HIGH ACCELERATION COCKPIT CONTROLLER LOCATIONS

Volume III - Onsite Pilot Evaluations

McDonnell Aircraft Company St. Louis, Missouri 63166

TECHNICAL REPORT AFFDL-TR-75-58, VOLUME III

FIGURE 1
HIGH ACCELERATION COCKPIT DESIGN AID

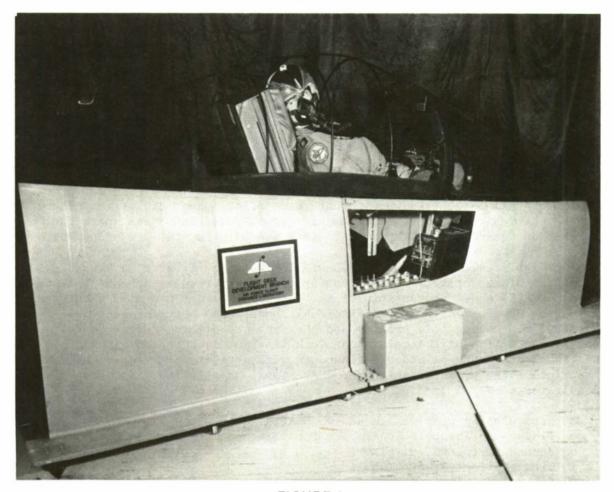
- o Head Rest Too large, restricts rear vision, cannot roll head when reclined. Possible modifications mentioned were shorter head rests and rollers to reduce helmet friction for improvement in head mobility and aft vision.
- o Rudder Pedals The need to readjust the pedals forward during articulation was experienced by nearly all pilots. The pilots would adjust the pedals in the upright position for maximum pedal throw which resulted in the need for readjustment when reclined. Use of limited displacement pedals with isometric overtravel should improve this. Incorporation of an electric adjust feature and/or automatic readjustment during articulation may be required. Some pilots also expressed the need for heel cups under high G loading. Due to the forward slant of the pedals many pilots found it difficult to apply the brakes.

- o Throttles The shape of the grips (contour and slope) was liked by almost all pilots however switch placement was less than ideal. Clearance between the throttles and sill was considered unacceptable by many pilots. More clearance is required (current clearance is 1/4 inch).

- o Flight Controller The shape of the grip received wide acceptance with very few complaints. Most pilots would have preferred that the seat recline switch operate in the reverse direction (forward for upright). A dedicated trim control is required as opposed to the integrated/mode select approach used in the design aid. A displacement stick was preferred over an isometric.

- o Arm Rests Arm rests are required in both the upright and reclined seat positions.
- o Seat Most pilots considered the seat very comfortable. In the reclined position some of the shorter pilots experienced interference between their shoulders and the lower portion of the head rest.

CONTROL/DISPLAY LAYOUT FIGURE 4

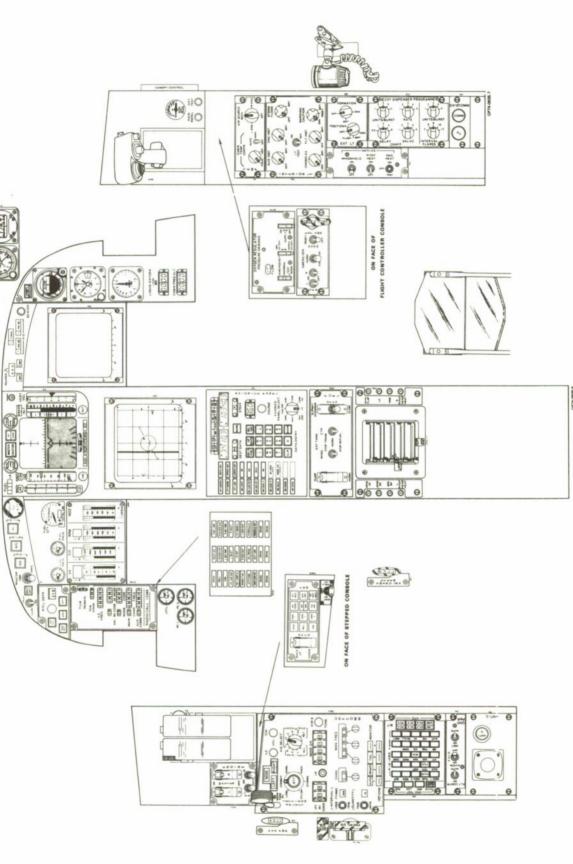
The location of the engine instrument group was downgraded by some pilots due to partial obscuring of the engine oil pressure gages and fuel gages. If these items were redesigned to improve visibility the rating should increase to the satisfactory range.

AREA EVALUATED	MEAN	STANDARD DEVLATION	PILOT COMMENTS
1. Location of engine instrument group with upright seat operation.	3.62	1.65	Portions of engine oil pressure and fuel gage obscured – Basic location acceptable

2. Location of Push to Jettison for upright seat operation.	1.92	0.81	Would like separate tank jettison and relocate selective jettison rotary. Basic location of control good.

20. Location of Emergency Speed Brake with seat upright.	4.05	1.49	Major downgrading due to elbow interference with sill and seat when operating this control - move forward to improve accessibility. (Located under left sill)

21. Location of Decoy Dispenser Programmer with seat upright.	3.05	1.05	Location acceptable based on use as compared to other panels. (Located on right console)

22. Location of Engine Control Panel with seat upright.	3.31	1.44	Some downgrading due to interference with landing gear control. (Located outboard of throttles)

23. Location of Landing/Taxi Lights with seat upright.	3.41	1.94	Some downgrading due to interference with landing gear control - difficult to see with throttles adjusted full aft. (Located below throttles)

24. Location of AFCS Panel with seat upright.	3.99	2.09	With throttle location pilot adjusted aft, panel was difficult to see and operate - caused low rating by pilots with short reach. (Located below throttles)

FIGURE 5
FLIGHT CONTROLLER FUNCTIONS

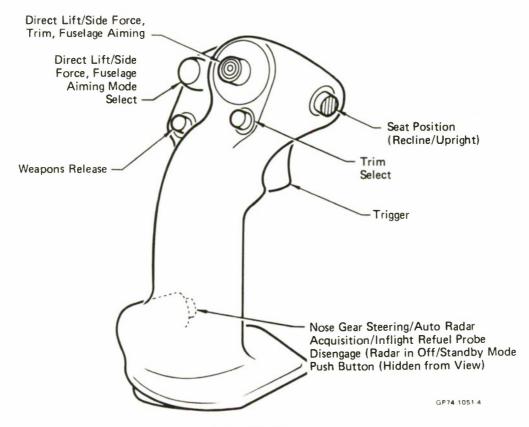
16. General contour or shape of flight controller.	2.26	1.01	Very well liked - only a small percentage of pilots with large hands downgraded shape.
17. Location of trim control on flight controller.	3.53	1.60	Location acceptable - pilots want dedicated trim control

18. Location of fuselage aiming mode on flight controller.	2.74	1.02	Location acceptable - new head like illustration in Figure 4 more desirable.
19. Shape and location of seat position switch on flight controller.	2.64	0.93	Location good - reshape head more like toggle - many pilots preferred to pull switch to recline as opposed to pushing.

Areas evaluated relative to the flight controller received satisfactory ratings except for the trim function. Although the question on the trim control was concerned only with location, many pilots gave a poor rating due to the integration of the trim function with the center isometric control. By providing a dedicated trim control the rating would be satisfactory. The shape of the flight controller received a very good rating by nearly all pilots.

FIGURE 6
THROTTLE CONTROL FUNCTIONS

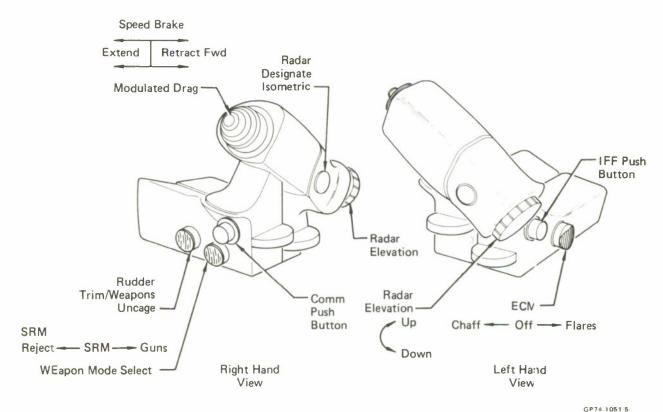
3. Shape and location of Weapon Mode Select switch on throttle.	3.72	1.82	Some pilots had difficulty reaching switch - should be different shape than rudder trim/weapons uncage switch.

4. Shape and location of Rudder Trim/Weapons Uncage switch on throttle.	4.13	1.66	Same comments as No. 3
5. Shape and location of ECM control on throttle.	4.58	1.73	Difficult to actuate with little finger would be better if ECM and IFF controls switched, reshape ECM switch head more like toggle,

6. Location of communications control on throttle.	2.61	1.11	Location would be improved if switched with speed brake control but location is good.
7. Shape and location of engine cutoff controls on throttle.	2.69	1.10	Based on function and frequency of use location is fair to good.

8. Orientation of throttles.	3.54	1.76	Basic orientation good but some interference with sill noted by pilots - need more.
9. General contour or shape of throttles.	2.51	1.29	Well liked by majority of the pilots - a small percentage with large hands felt that the grip was too small.

10. Shape and location of Speed Brake/Modulated Drag Control on throttle,	2.21	1.06	Location fine, however many pilots felt that comm control should be located in this area. Reshape speed brake switch head like slide switch.

11. Location of radar elevation control on throttle.	2.85	1.22	Some interference with the sill was noted when operating this rotary.
12. Location of radar designate control on throttle.	3.97	1.64	Index or forefinger location would improve rating. If comm and speed brake/modulated drag functions interchanged there is adequate internal grip space for index finger location.

Many of the switch functions on the throttle received an unsatisfactory rating including the weapons mode select, rudder trim/weapons uncage, ECM, radar designate, and IFF functions. Although it may prove impractical to raise all ratings to the satisfactory range, these ratings can be improved by slightly increasing the size of the throttles thereby permitting better location of the switches. Improved switch head design would also improve the ratings. Increasing the size of the throttles would require a slightly wider sill width. The remaining switch locations, including the basic shape of the throttles, received satisfactory ratings but there is potential for improvement as noted in Table 7.

FIGURE 14
SUGGESTED CONTROL/DISPLAY LAYOUT

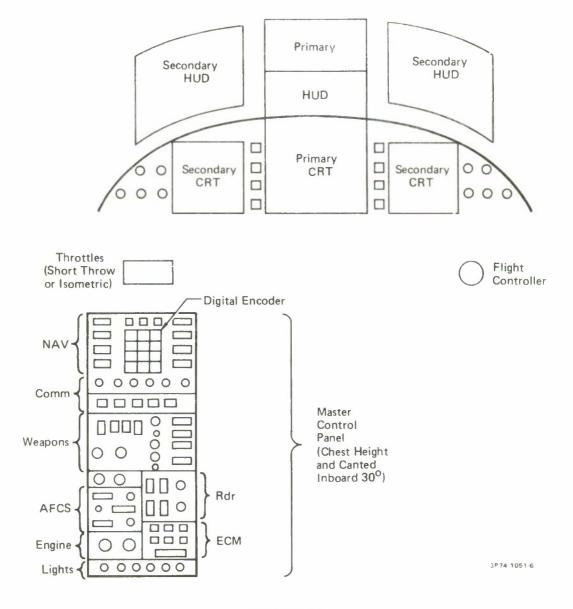
"This master control panel idea may seem an overly ambitious concept, but if everything from TACAN channels and headings to UHF frequencies can be set in by the digital encoder or an analog slew system such as the throttle isometric button, then the pilot could gain a proficiency with this system that would be better than trying to "find a place" for each separate system in the cockpit and trying to put them all within reach."
